**Request for Additional Information No. 64 (994, 995, 996, 997), Revision 0**

**U. S. EPR Standard Design Certification**

**AREVA NP Inc.**

**SRP Section: 05.03.01 - Reactor Vessel Materials**

Figure 5.3-4—Reactor Pressure Vessel

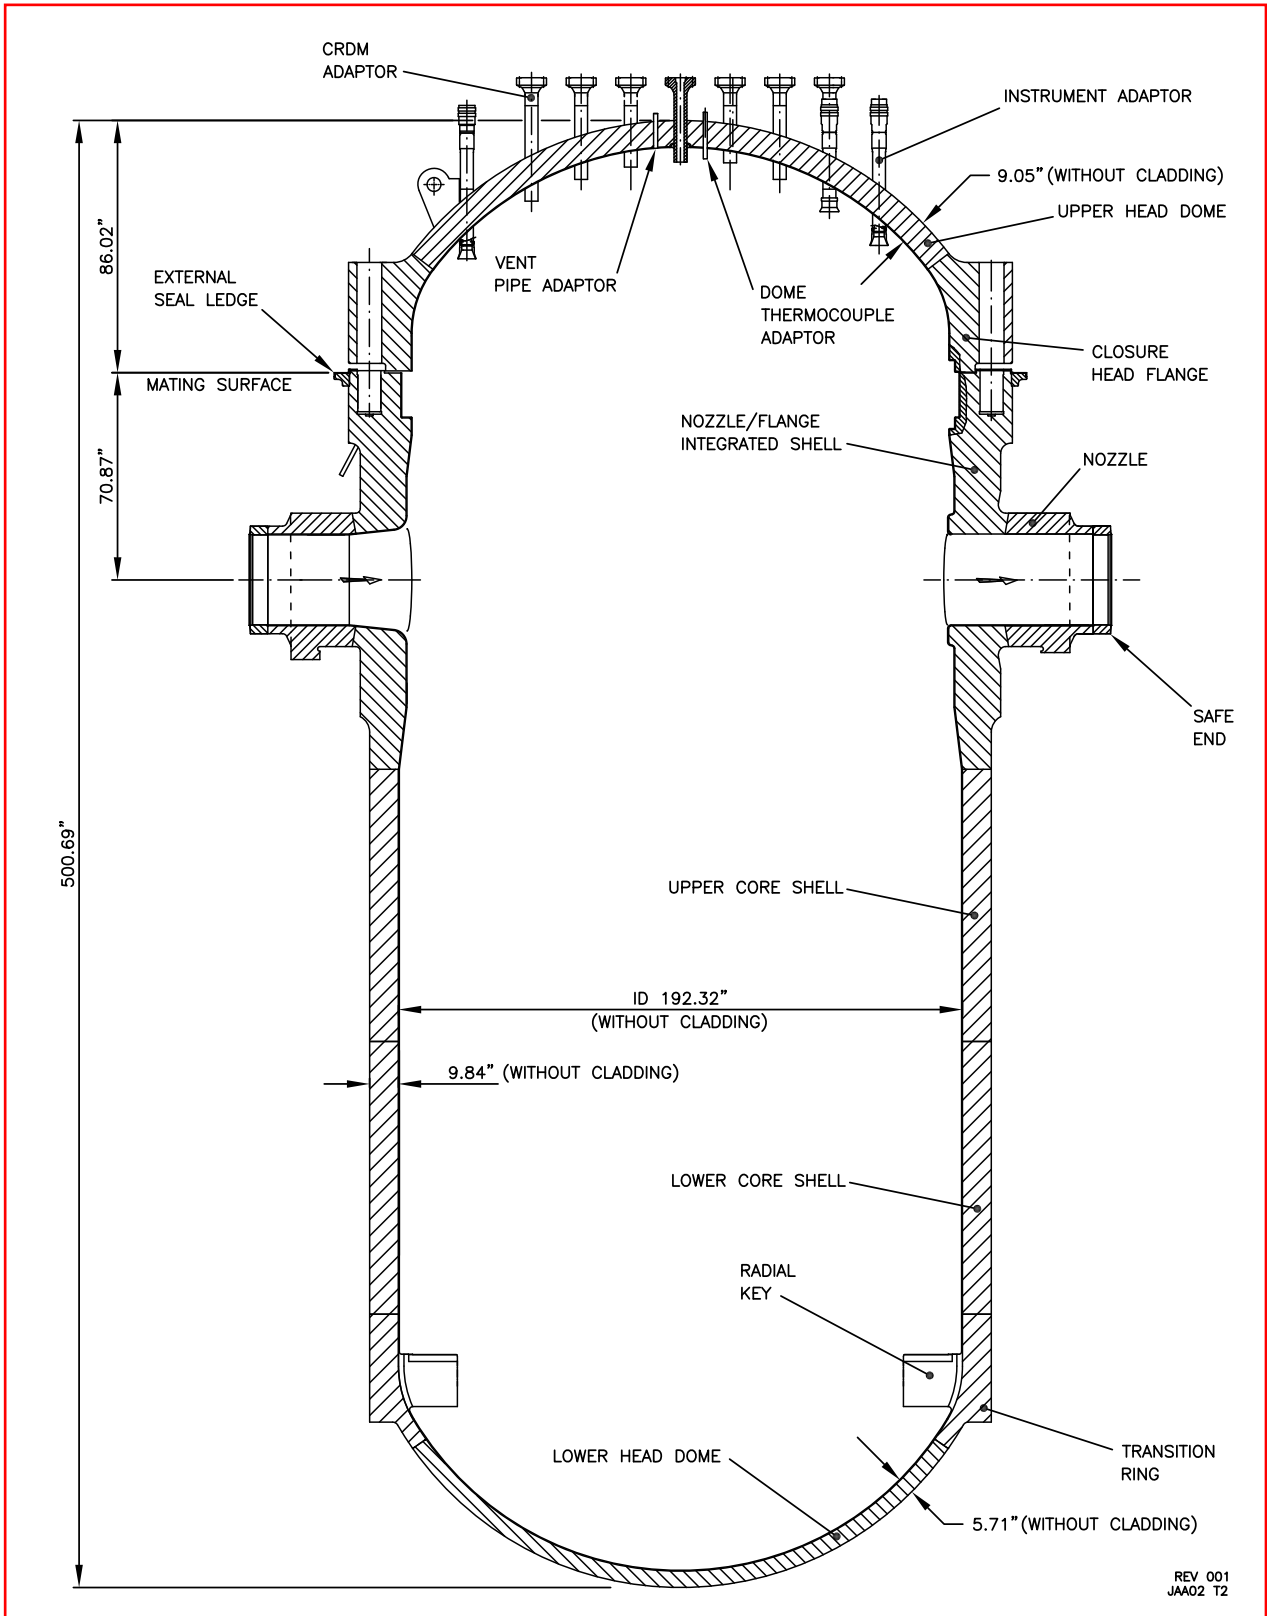
Figure 5.1-2 “RCS Layout” indicates the principal dimensions of RCS components in relation to their surrounding structures. In order for the staff to evaluate reactor pressure vessel (RPV) functionality and ensure standardization of the vessel is achieved, the key RPV dimensions (e.g. thickness, height, width, and location of nozzles) should be provided in the FSAR.

U.S. EPR FSAR Tier 2, Section 5.3.3.1 will be revised to include a statement making reference to a new, Table 5.3-7, for RPV design data. U.S. EPR FSAR Tier 2, Table 5.3-7 will be added and Figure 5.3-4 will be revised to include dimensions for vessel height, diameter, thickness and location of nozzles.

U.S. EPR FSAR Tier 2, Section 5.3.3.1 and Figure 5.3-4 will be revised as described in the response and indicated on the enclosed markup.
